**Hastings District Council**

**Commissioner Hearing Meeting**

**LIMITED NOTIFIED RESOURCE CONSENT APPLICATION FROM  
No.8 STUDIOS LIMITED TO ESTABLISH A SCREEN PRODUCTION  
STUDIO IN THE RURAL ZONE AT GORDON ROAD AND 376  
PARKHILL ROAD, TE AWANGA (RMA20210474)**

| ITEM                     | SUBJECT  | PAGE          |
|--------------------------|--|---------------|
| <b>Attachment 2</b>      | S92 Further Information Required Letter  | <b>Pg 3</b>   |

**Figure 1: Proposed access road connection to end of Parkhill Road**

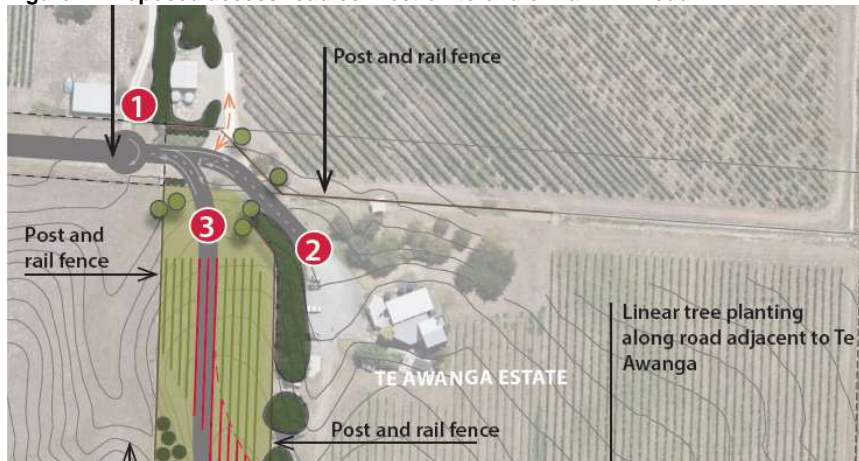
The plans submitted with the application provide insufficient detail for a detailed analysis of the operation. The current design could be misleading and result in conflicts between drivers' movement to/from Te Awanga Estate and the proposed studios.

Figure 23: Proposed indicative layout for the Parkhill Road/Raymond Road intersection

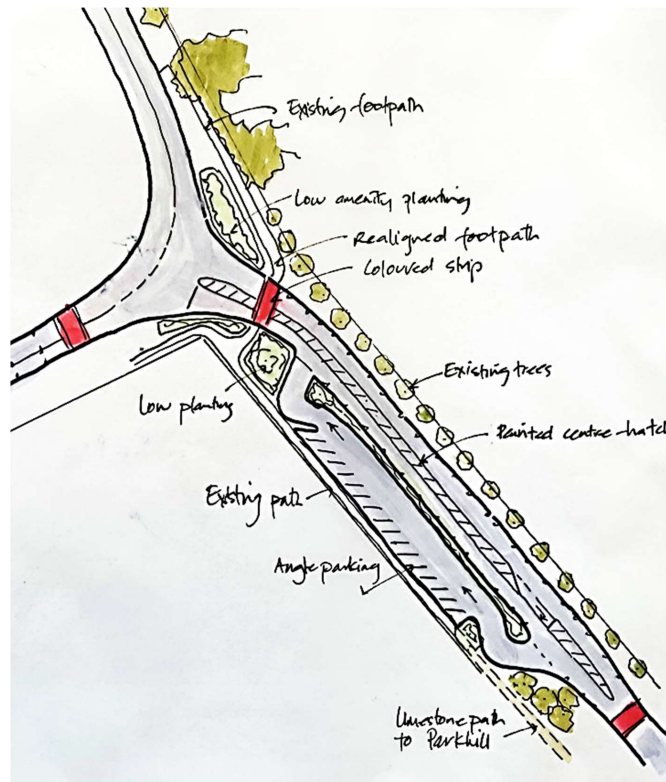
Remedial treatments for the Parkhill Road/Raymond Road intersection are proposed and are indicated in Figure 23 of the TIA. However, further clarification of the nature of the treatments is required.
